Technical Bulletin

Tracking Number: TBACTH-001

Model / Part Number: ACTH / ACTH11

Re: Thermostat display function

Adjusted DIP settings for display always ON

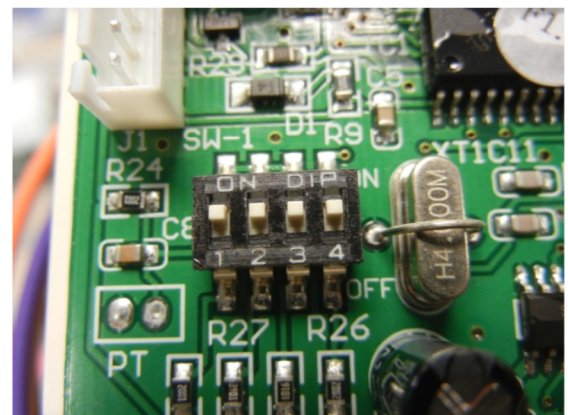
It is possible to change the display to remain always ON and showing the ambient temperature rather than turn OFF after 30 seconds. This can be done by changing DIP switch #1 from its default setting of OFF to ON. The DIP switch is accessible once the front cover is removed.
